UNITED STATES
DEPARTMENT OF THE INTERIOR
BUREAU OF LAND MANAGEMENTFORM APPROVED
OMB No. 1004-0135
Expires: January 31, 2004**SUNDRY NOTICES AND REPORTS ON WELLS**

Cone Federal #14

**Proposed Plugging Procedures
Cano Petro of New Mexico, Inc.
Cone Federal #14
30-041-20495**

**Cone Federal 14
30-041-20495
Tom R. Cone
May 7, 2024
Conditions of Approval**

Cano Petro of New Mexico, Inc.
Cone Federal #14
API 30-041-20495
WBD After PA

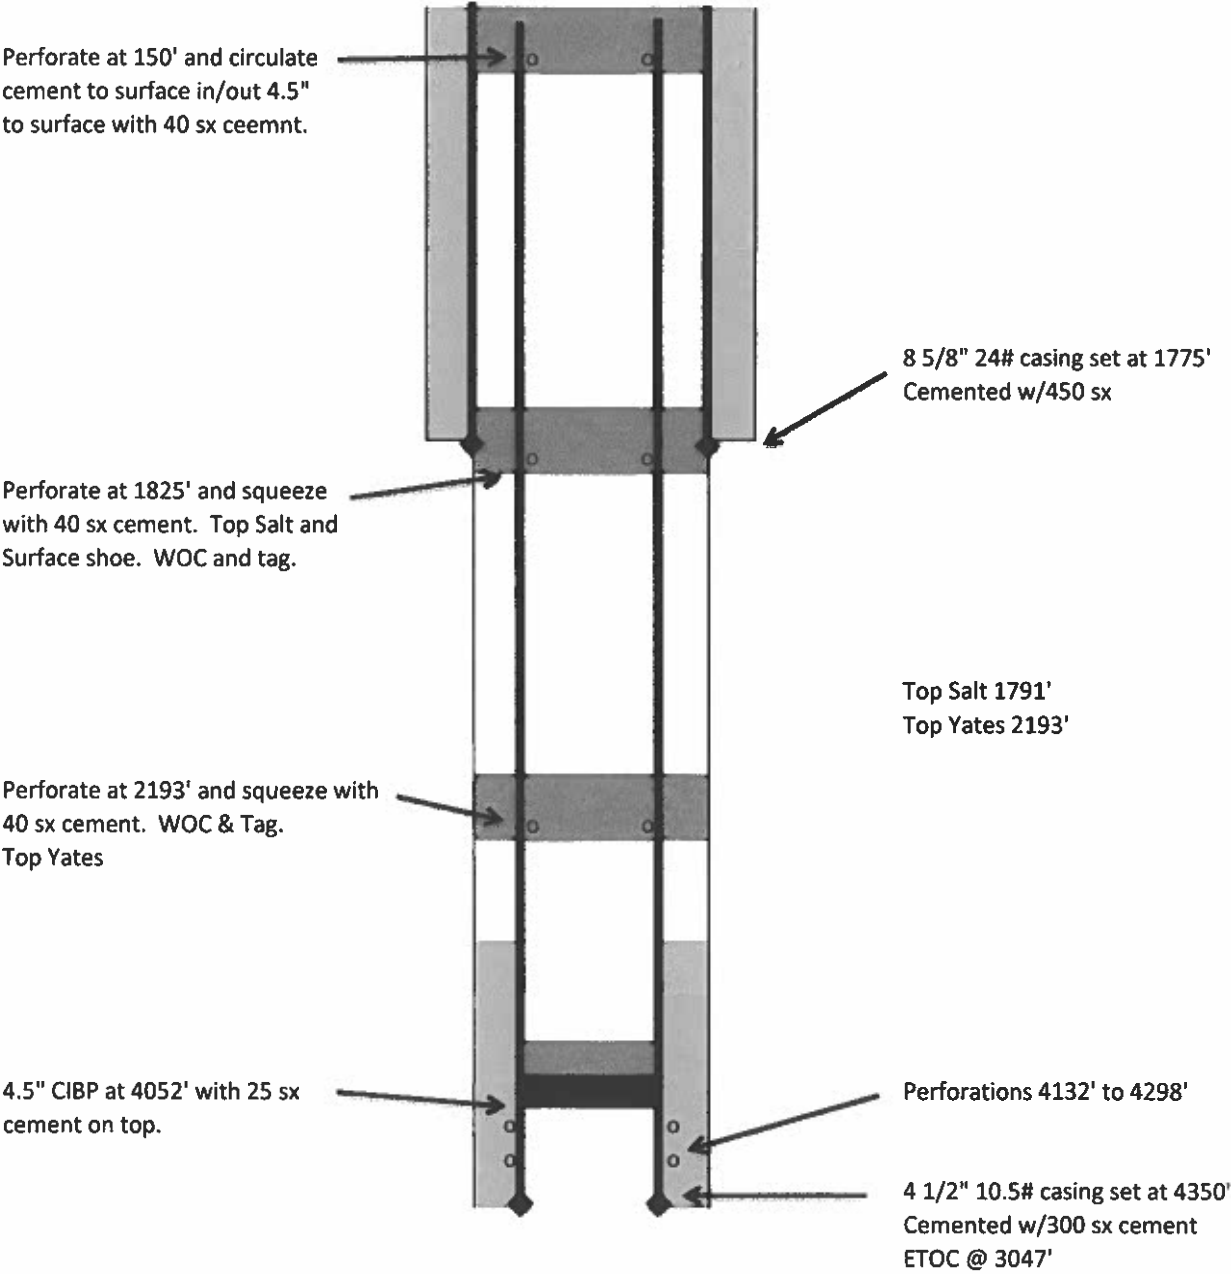
1. Operator shall place a CIBP at 4,052' (50'-100' above top perf) and place 25sx of Class C cement on top. WOC and TAG.
2. Operator shall place a balanced Class C Cement plug from 3,112'-2,870' to seal the Queen and Grayburg Formations.

3. Operator shall perf at 2,243' and squeeze cement class C cement to 2,121' to seal the Yates and bottom of Salt. WOC and TAG.
4. Operator shall perf at 1,840' and squeeze cement class C cement to 1,713' to seal the top of Salt, Rustler and 8-5/8" casing shoe. WOC and TAG.

5. Operator shall perf at 150' and squeeze cement class C cement to surface as proposed.
6. Dry hole marker must be below ground.
7. Surface reclamation will need to be completed once the well bore has been plugged. Please contact rflores@blm.gov for additional information.
